Memo To: El Paso County Planning and Community Development

From: Core Engineering Group, LLC.

Subject: SF17-11 Carriage Meadows South at Lorson Ranch Filing No. 1 Final Plat 2nd Review - Response to Comments

Date: August 14, 2017

<div>CARRIAGE MEADOWS SOUTH FINAL GRADING AND EROSION CONTROL PLAN</div>		DATE	
		JUNE 20, 2017	
		PROJECT NO.	
		100.030	
		SHEET NUMBER	
		C4.13	
TOTAL SHEETS:		17

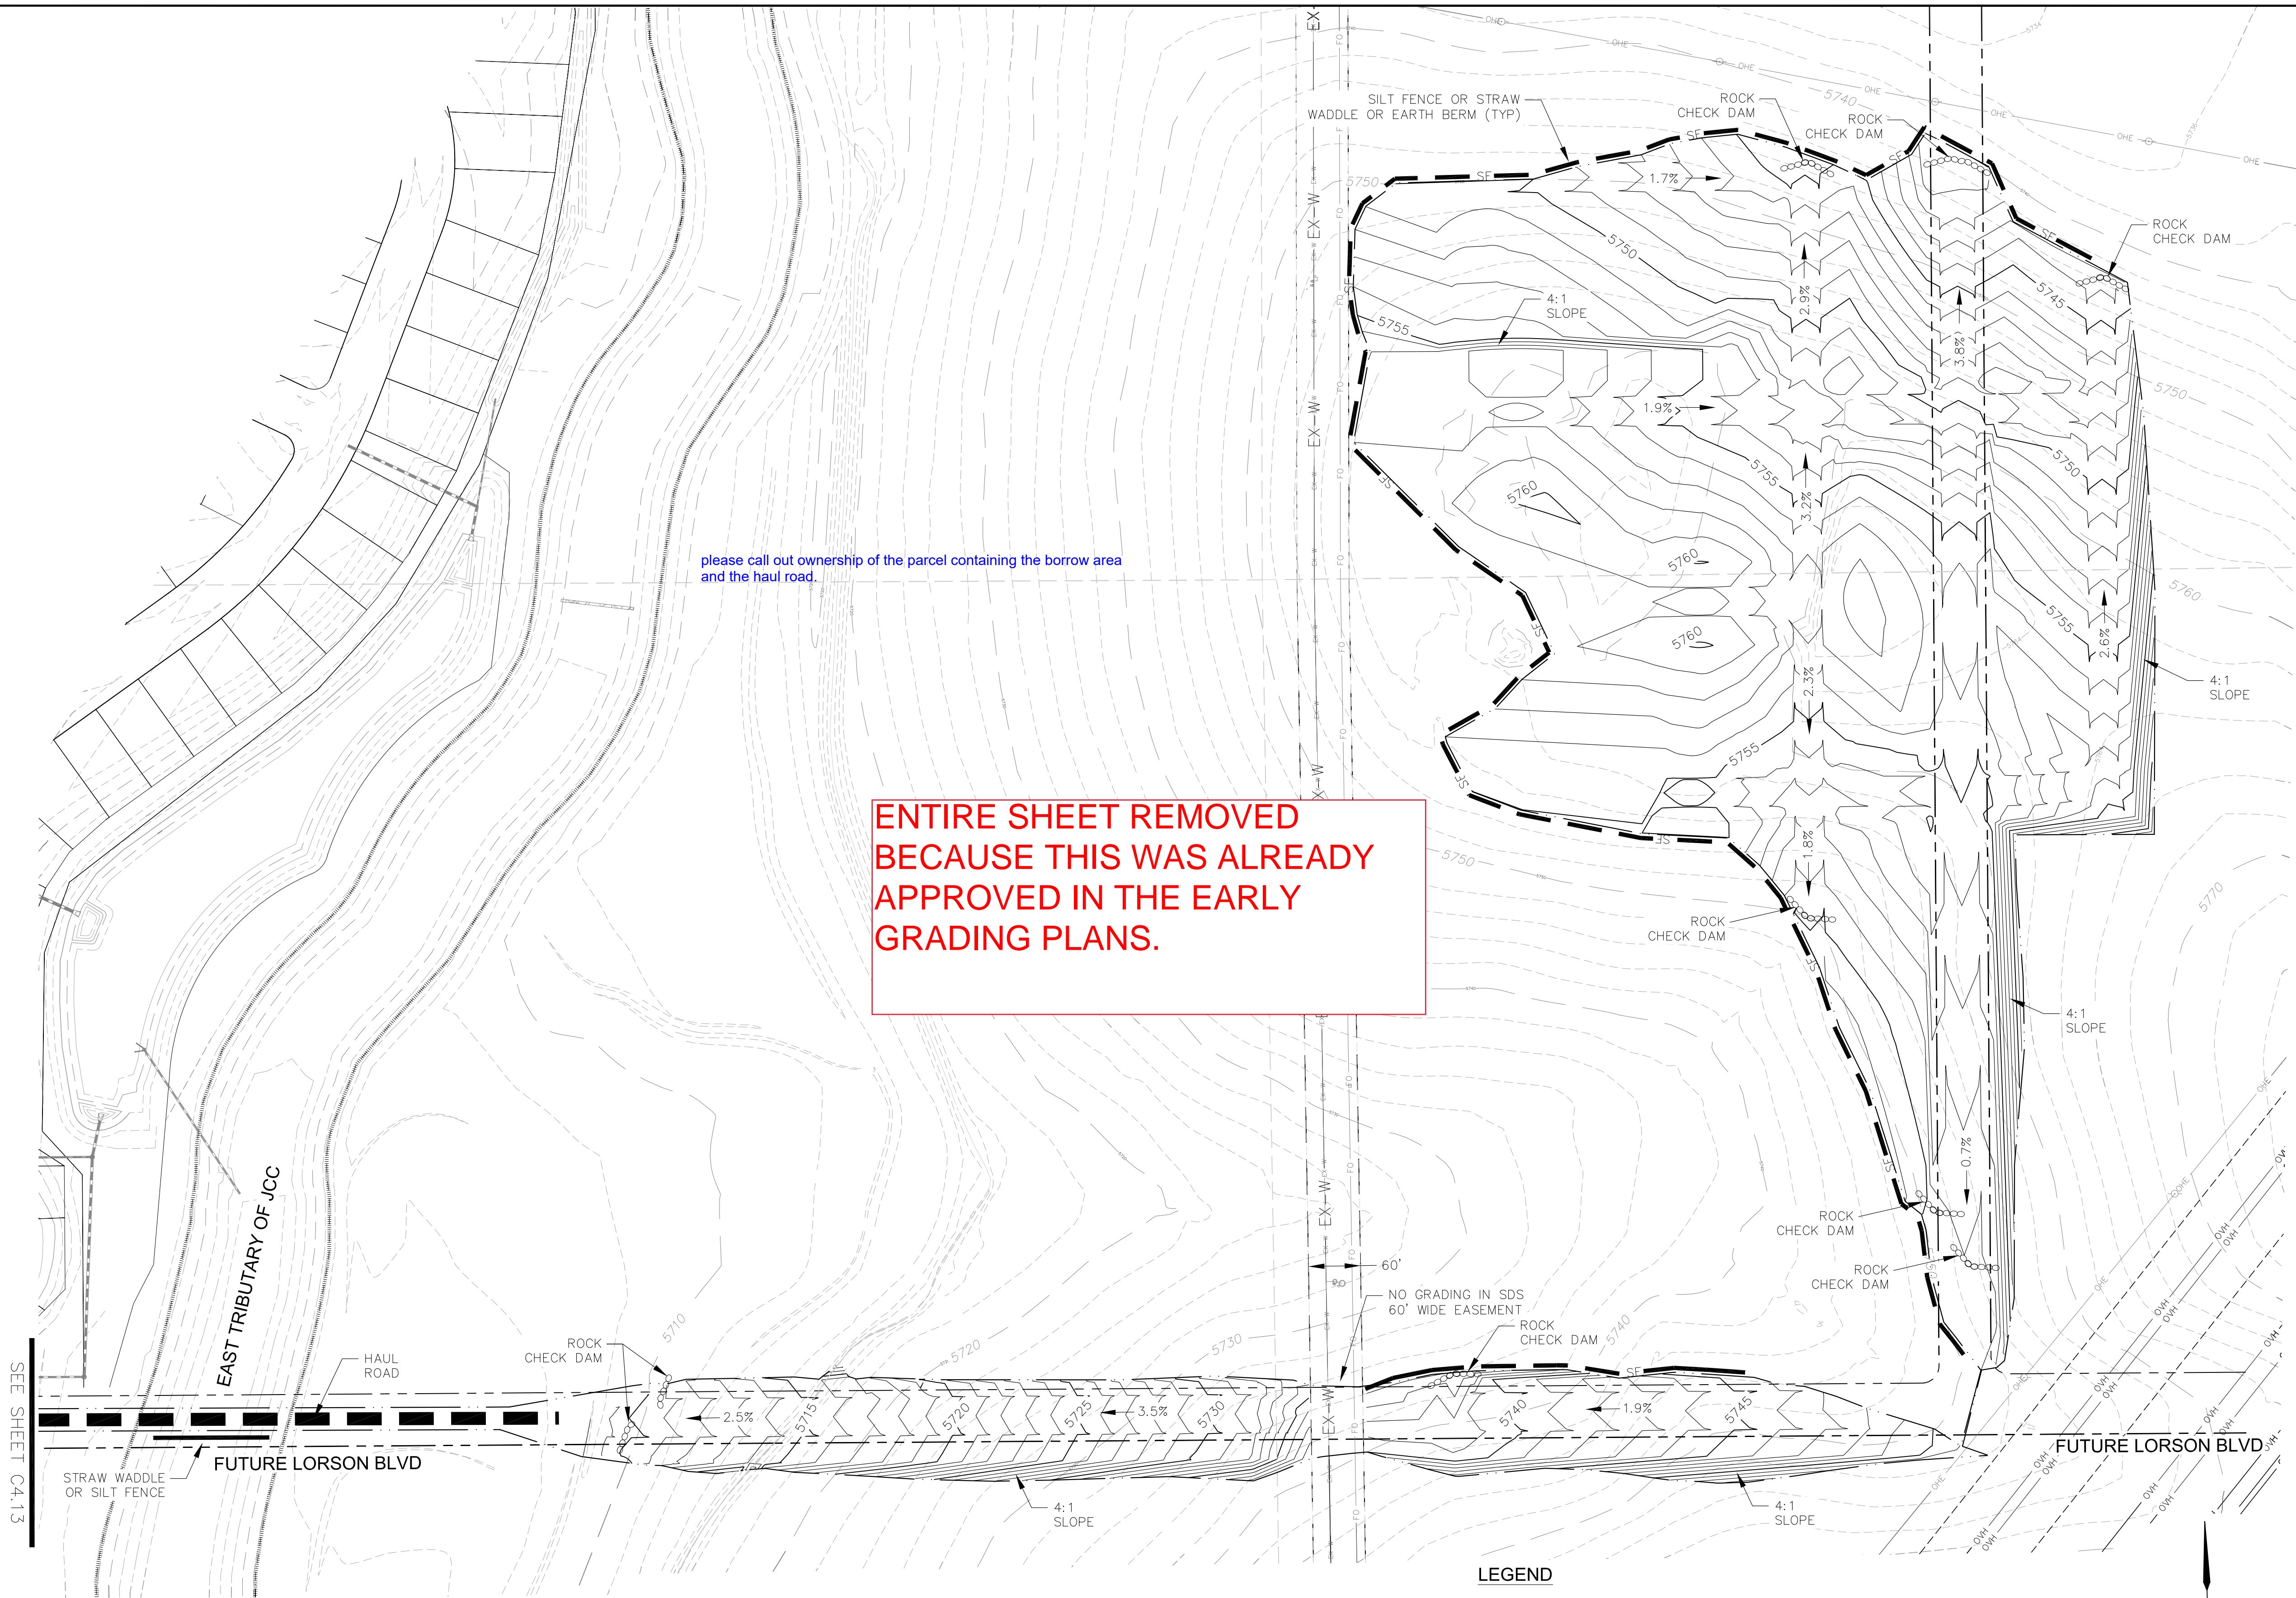
Please call out ownership of all parcels affected by this plan.

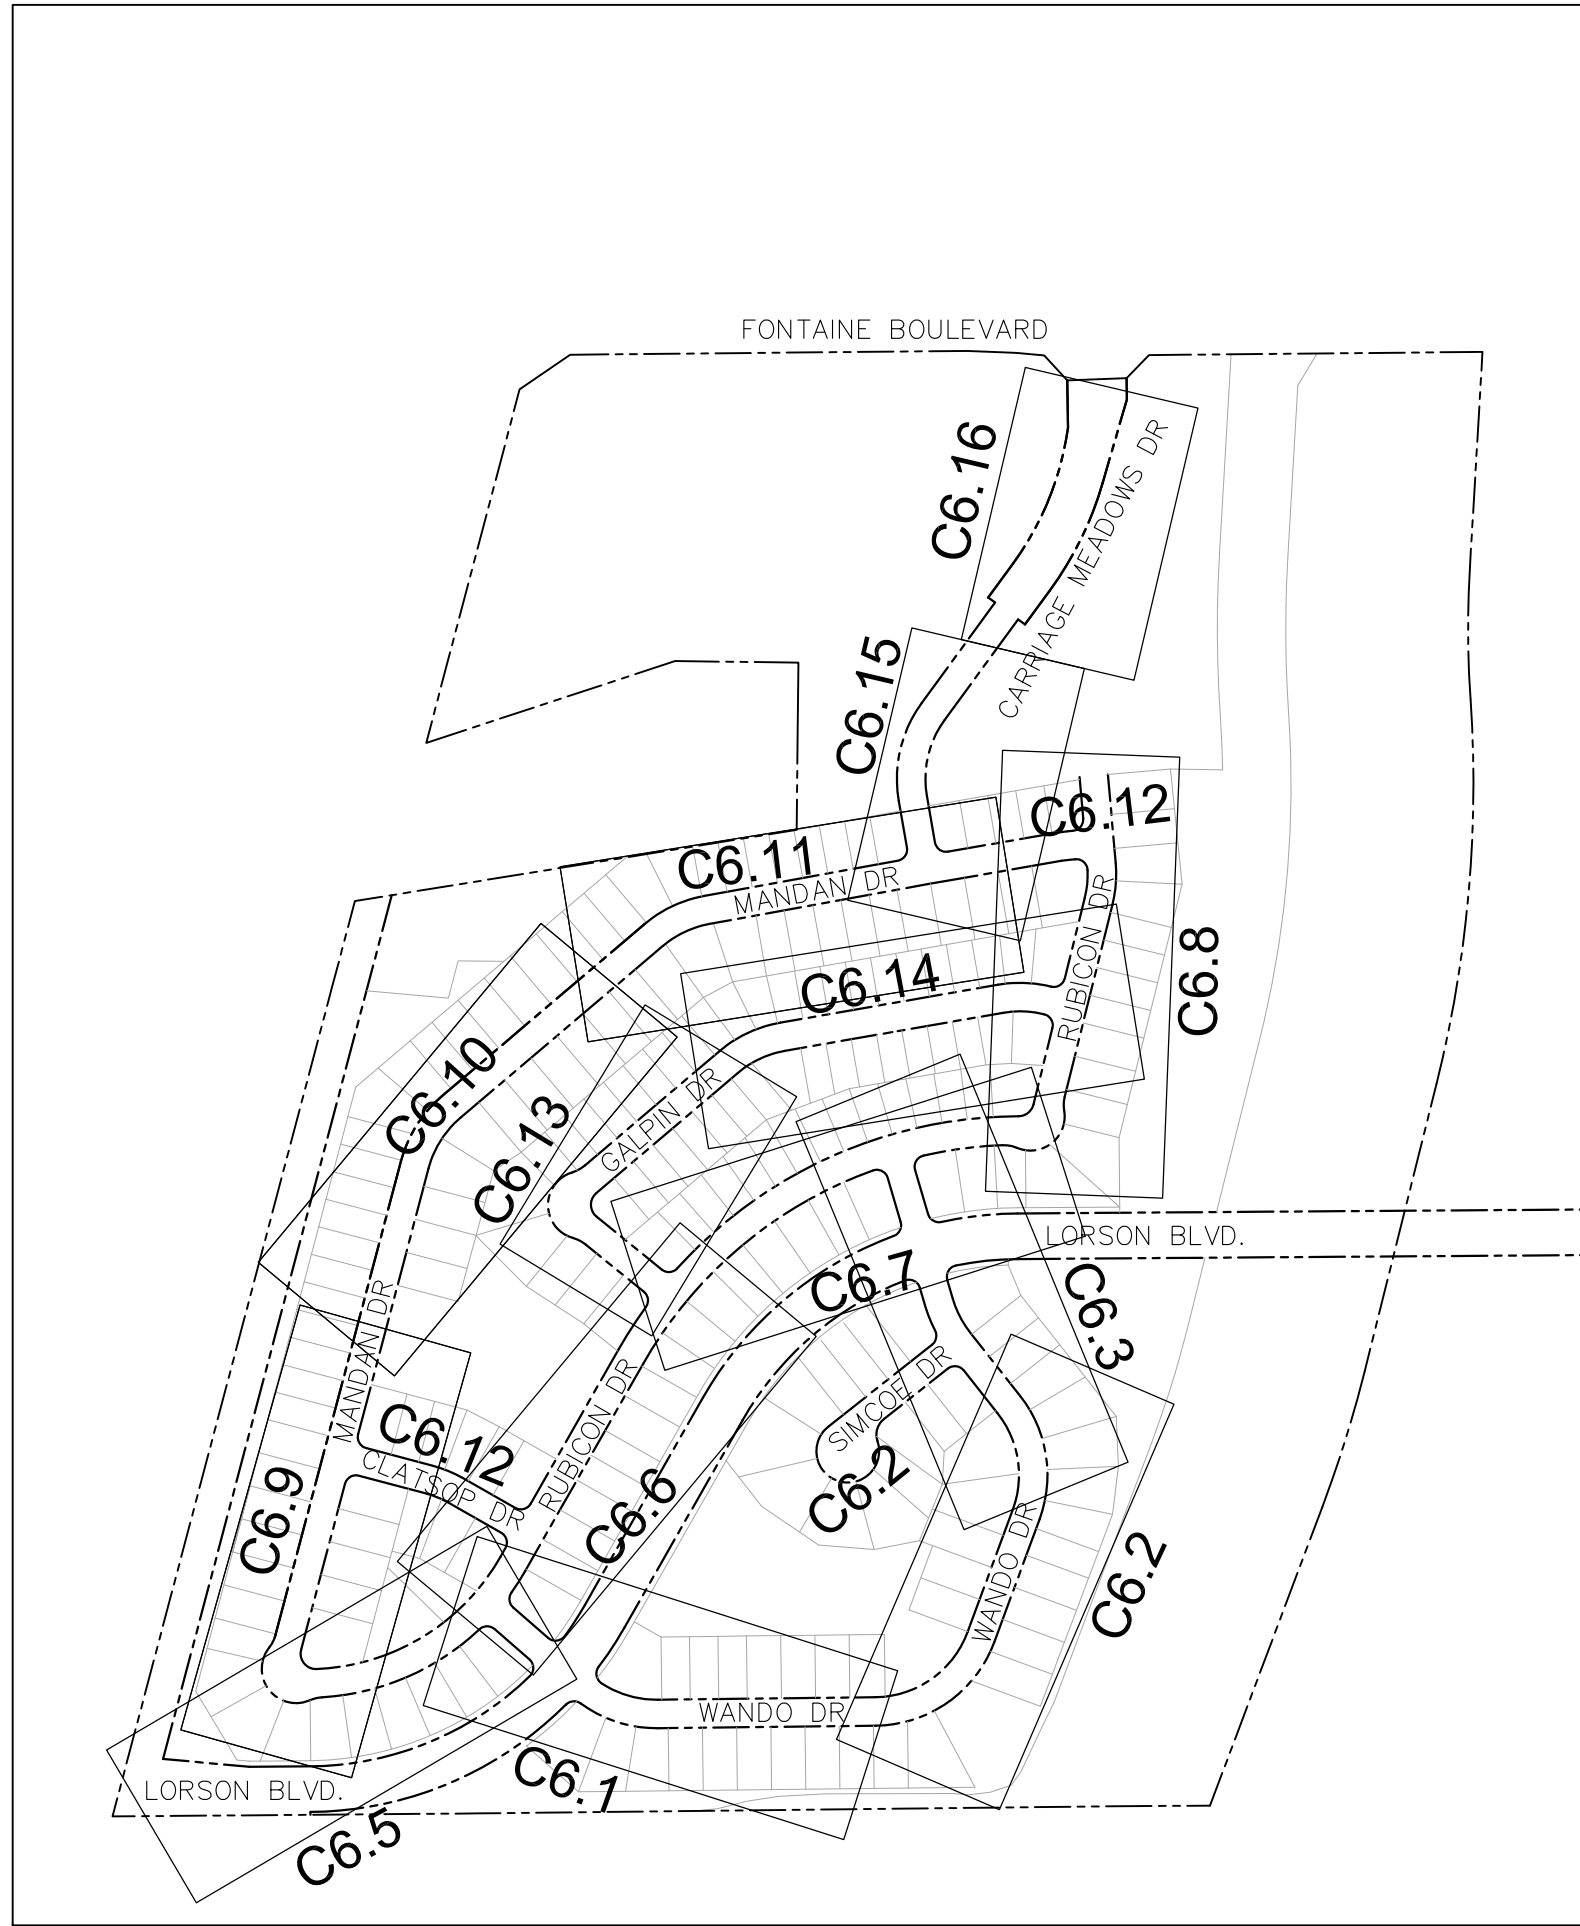
Please confirm compliance with section ECM
3.3.1, angle of confluence.

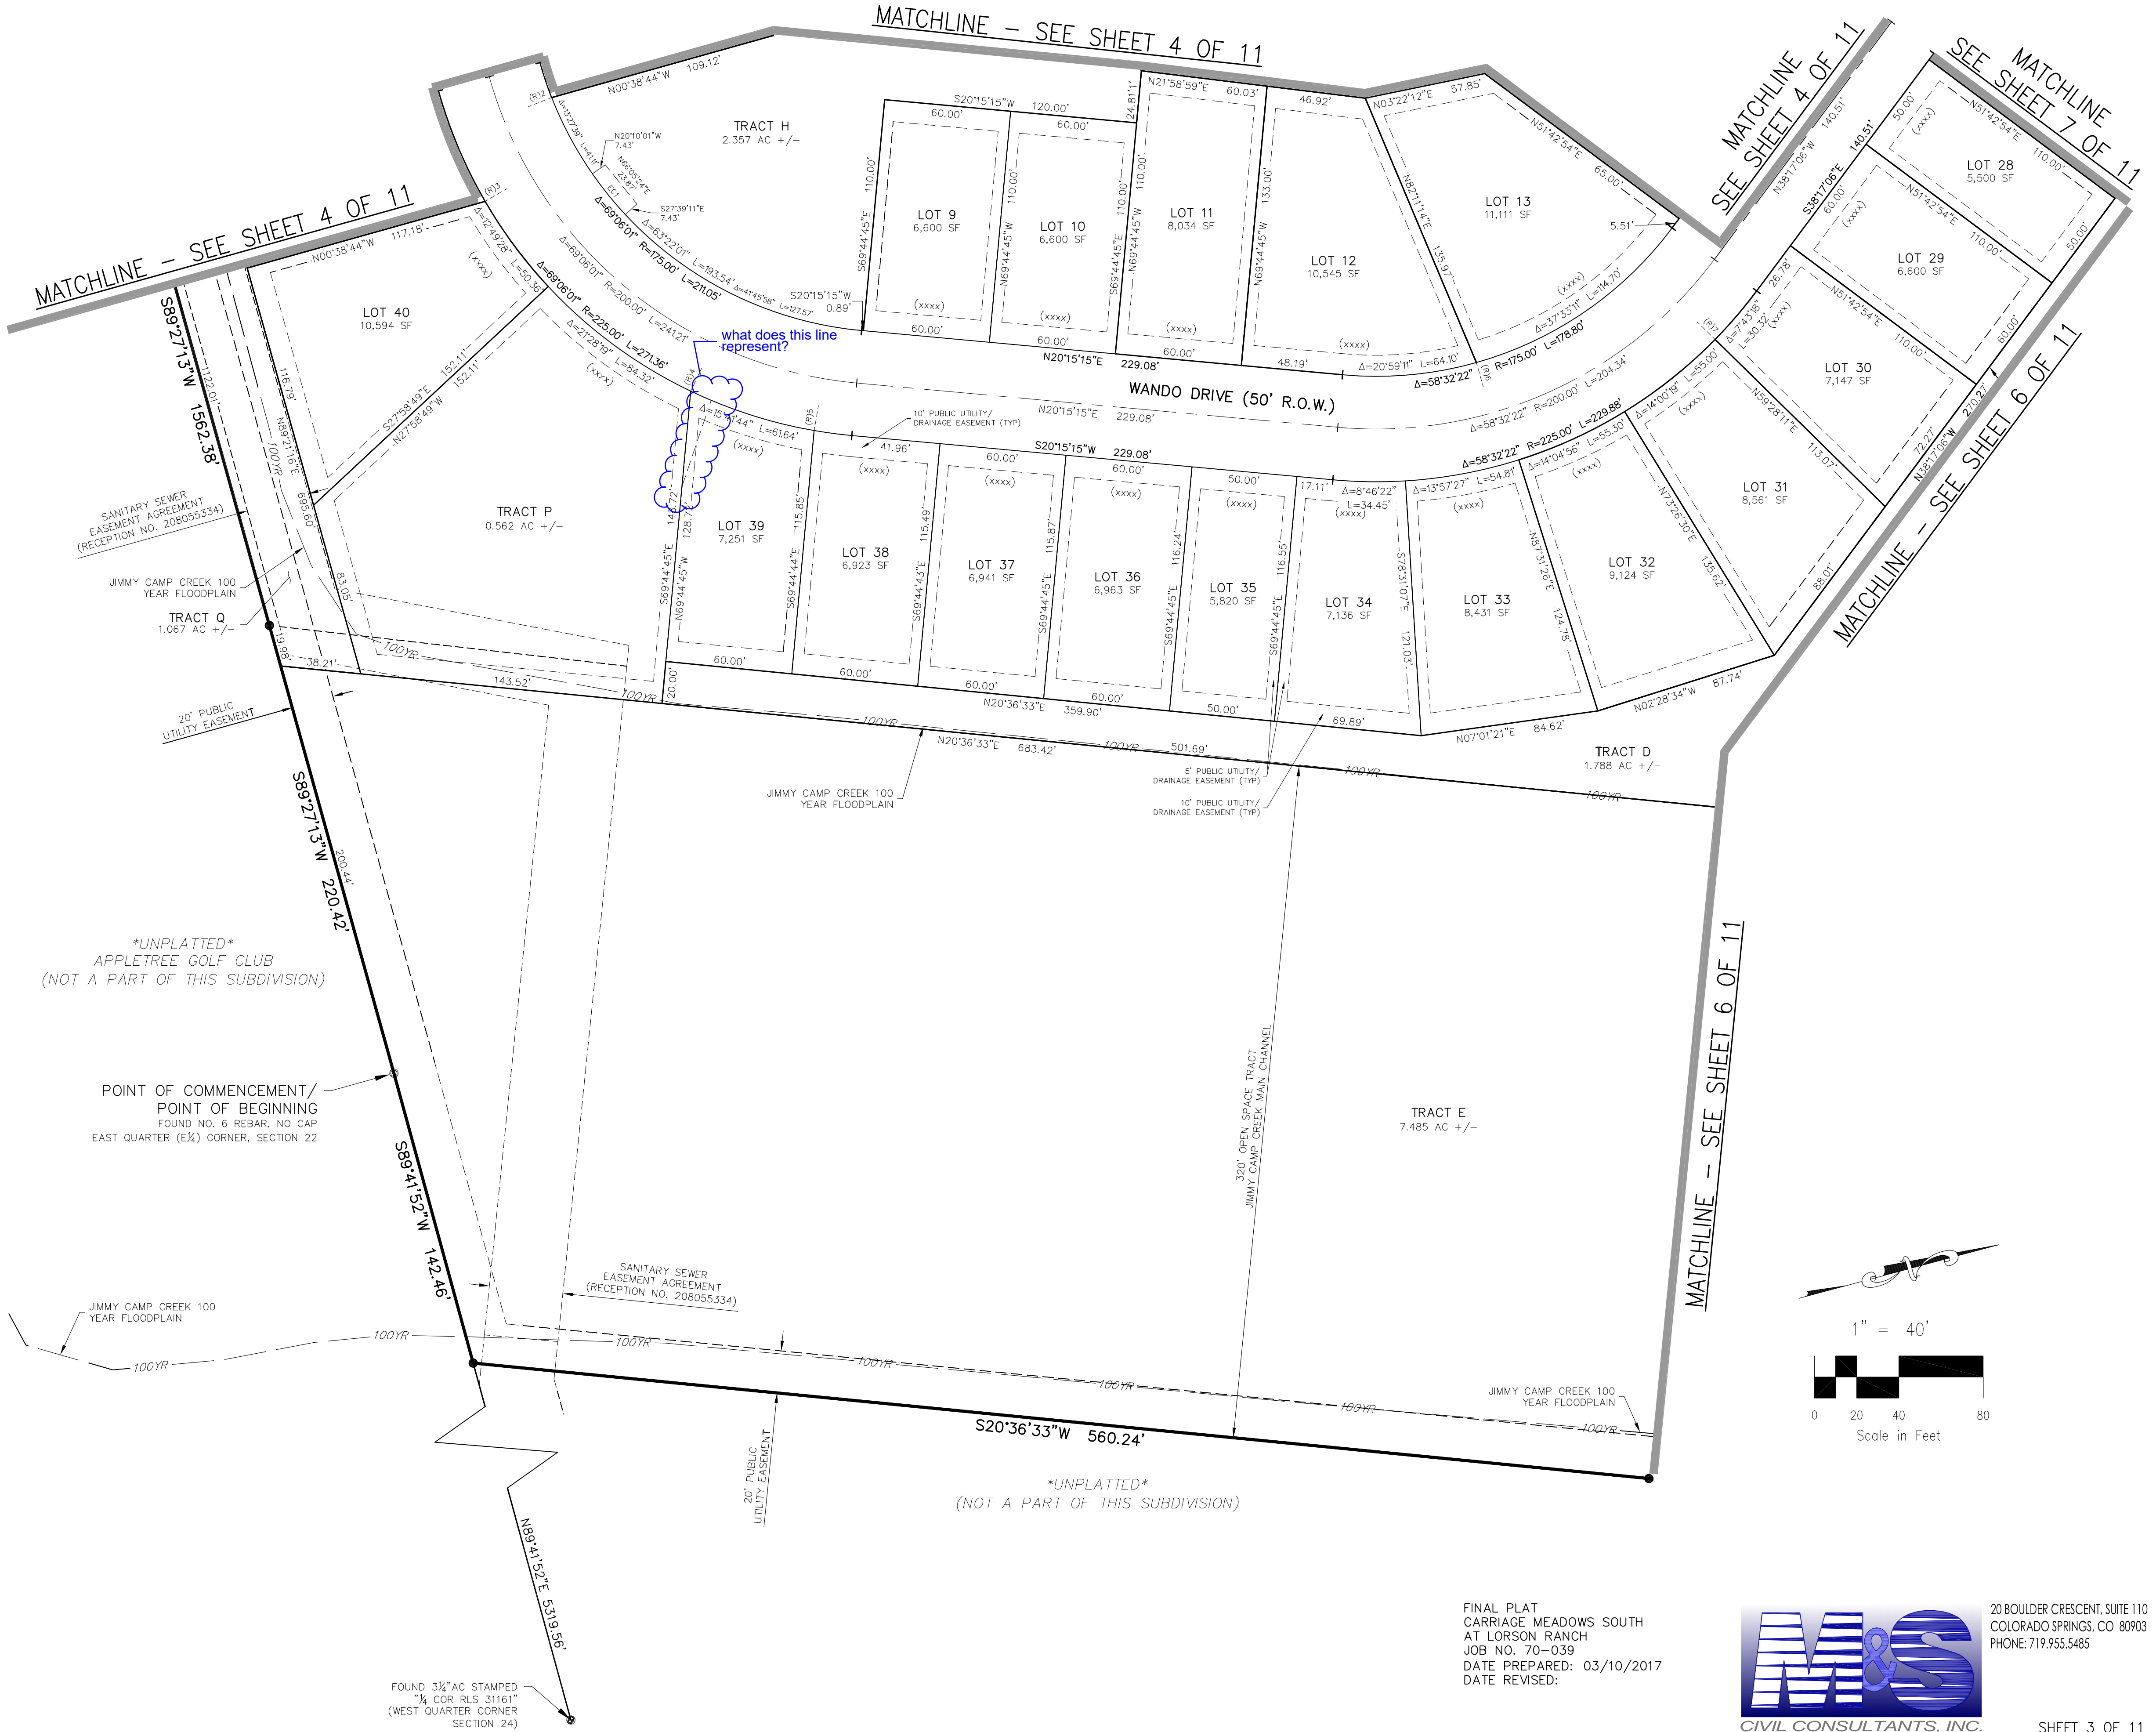
Please provide a reference label as to where we are in Lorson: this sheet (following sheets) is confusing as to location: Jimmy Camp Creek, Marksheffel
